# DESIGN
# FOR
# TEMPORARY BRIDGE

HANCOCK ER BRF 0174
(16)
HANCOCK, VERMONT

PARENT CONSTRUCTION
INC
HINESBURG, VERMONT

Vermont Agency of Transportation
RECEIVED
HANCOCK ER BRF 0174(16) DETOUR PLANS_RESUB 3-11-2013.pdf
CK'D BY AG/JTS OK'D BY WDL
March 4, 2013
RESUBMIT YES --------
BY KMH DATE 03/11/13

LAYOUT SHEET
SCALE 1" = 20'-0"
20 0 20
Vermont Agency of Transportation
RECEIVED
CK'D BY AG/JTS
OK'D BY WDL
March 4, 2013
RESUBMIT YES
BY KMH
DATE 03/11/13
PROJECT NAME: HANCOCK
PROJECT NUMBER: ER BRF 0174(16)
DETOUR LAYOUT PLAN
P2 OF 5

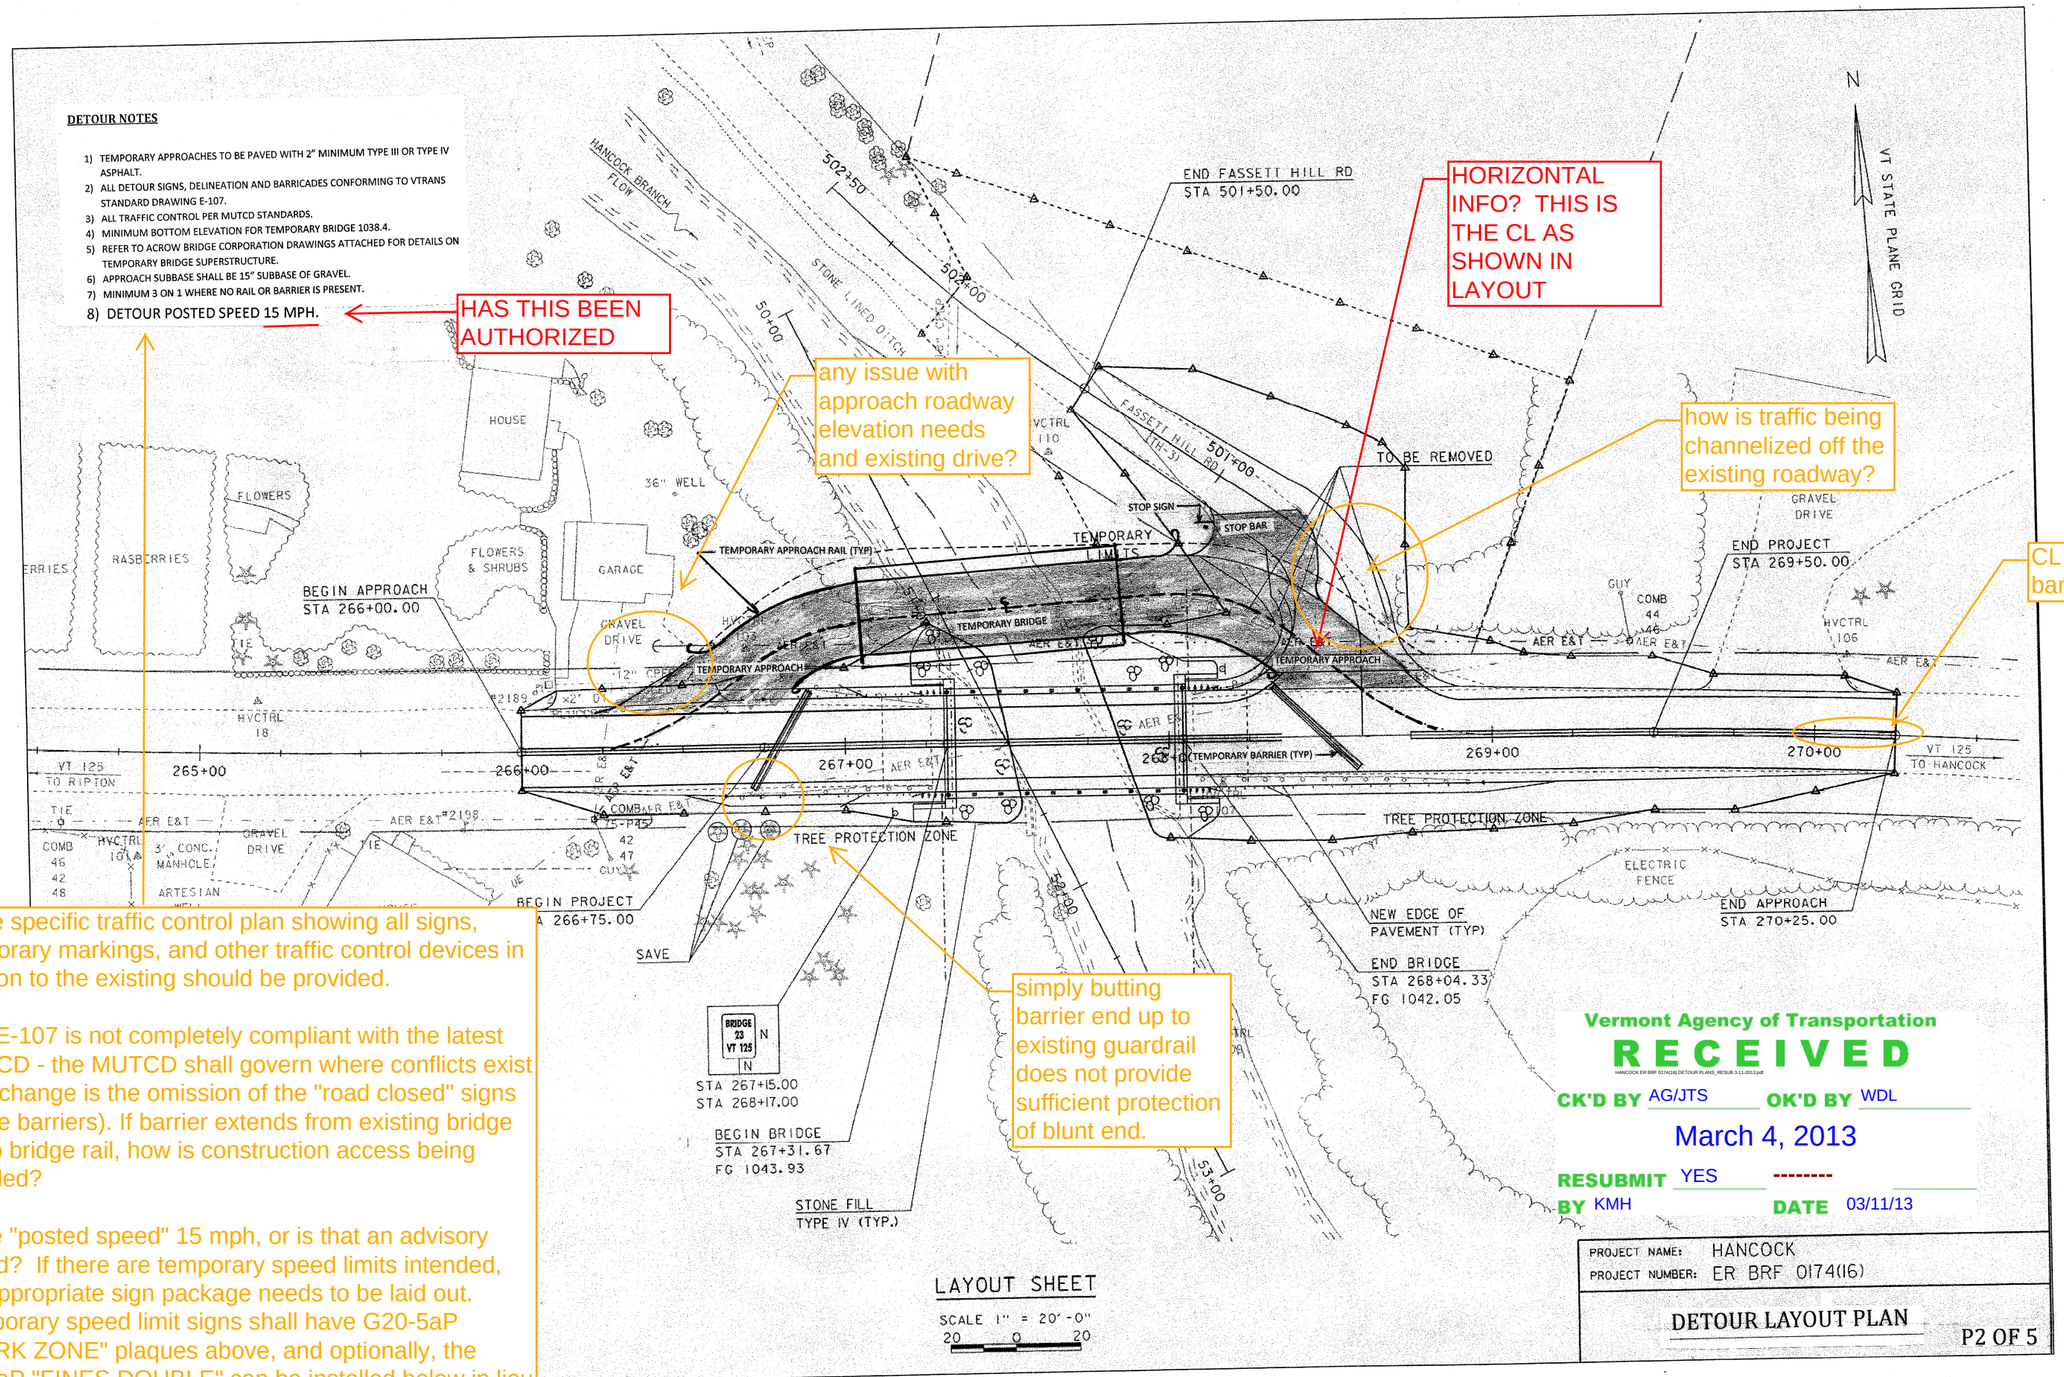
6) APPROACH SUBBASE SHALL BE 15" SUBBASE OF GRAVEL.
7) MINIMUM 3 ON 1 WHERE NO RAIL OR BARRIER IS PRESENT.
8) DETOUR POSTED SPEED 15 MPH.
HAS THIS BEEN AUTHORIZED
any issue with approach roadway elevation needs and existing drive?
HORIZONTAL INFO? THIS IS THE CL AS SHOWN IN LAYOUT
how is traffic being channelized off the existing roadway?
CL looks like barrier symbology
HANCOCK BRANCH FLOW
STONE LINED DITCH
END FASSETT HILL RD
STA 501+50.00
FASSETT HILL RD (TH-3)
TO BE REMOVED
STOP SIGN
STOP BAR
TEMPORARY LIMITS
TEMPORARY APPROACH RAIL (TYP)
TEMPORARY BRIDGE
TEMPORARY APPROACH
TEMPORARY BARRIER (TYP)
BEGIN APPROACH
STA 266+00.00
GRAVEL DRIVE
END PROJECT
STA 269+50.00
HOUSE
36" WELL
FLOWERS
RASBERRIES
FLOWERS & SHRUBS
GARAGE
HVCTRL 110
HVCTRL 18
HVCTRL 105
AER E&T
COMB 44 46
GUY
VT STATE PLANE GRID
N
VT 125 TO RIPTON
VT 125 TO HANCOCK
265+00
266+00
267+00
268+00
269+00
270+00
TREE PROTECTION ZONE
ELECTRIC FENCE
NEW EDGE OF PAVEMENT (TYP)
END BRIDGE

STA 268+04.33
FG 1042.05
END APPROACH
STA 270+25.00
BEGIN PROJECT
STA 266+75.00
SAVE
BRIDGE 23 VT 125
STA 267+15.00
STA 268+17.00
BEGIN BRIDGE
STA 267+31.67
FG 1043.93
STONE FILL TYPE IV (TYP.)
simply butting barrier end up to existing guardrail does not provide sufficient protection of blunt end.
A site specific traffic control plan showing all signs, temporary markings, and other traffic control devices in relation to the existing should be provided.
--
FYI, E-107 is not completely compliant with the latest MUTCD - the MUTCD shall govern where conflicts exist (one change is the omission of the "road closed" signs on the barriers). If barrier extends from existing bridge rail to bridge rail, how is construction access being handled?
--
Is the "posted speed" 15 mph, or is that an advisory speed? If there are temporary speed limits intended, the appropriate sign package needs to be laid out. Temporary speed limit signs shall have G20-5aP "WORK ZONE" plaques above, and optionally, the R2-6aP "FINES DOUBLE" can be installed below in lieu of using the VR-355 "FINES DOUBLED IN WORK ZONE" sign.

## TRAFFIC CONTROL PLAN TWO LANE HIGHWAY PAVED DETOUR WITH TEMPORARY TRAFFIC BARRIER

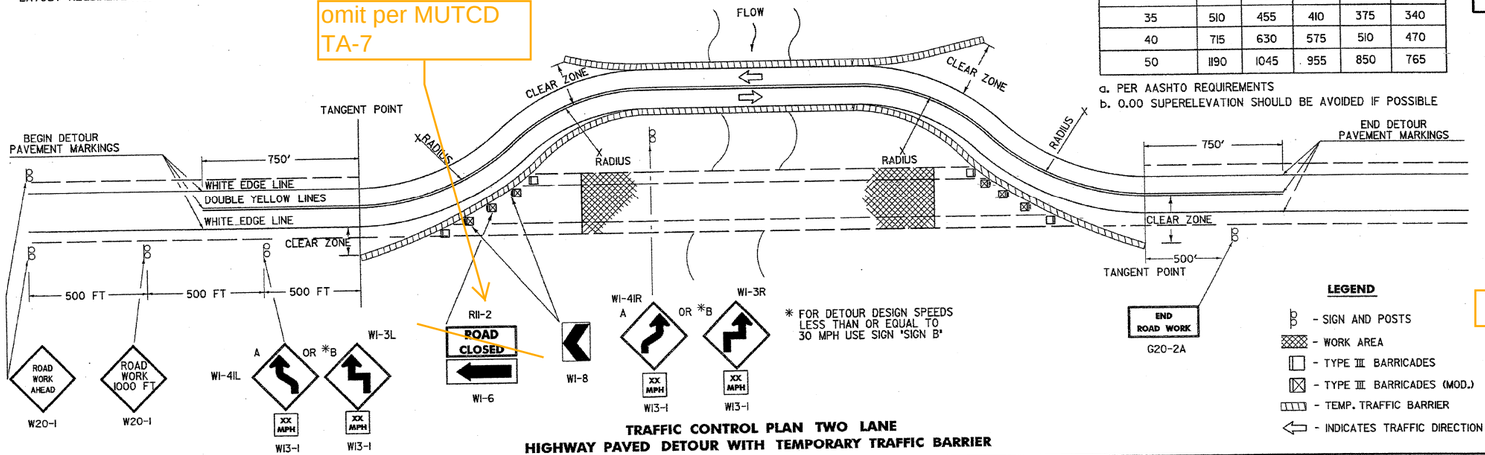
omit per MUTCD TA-7

is 15 mph design speed justified?
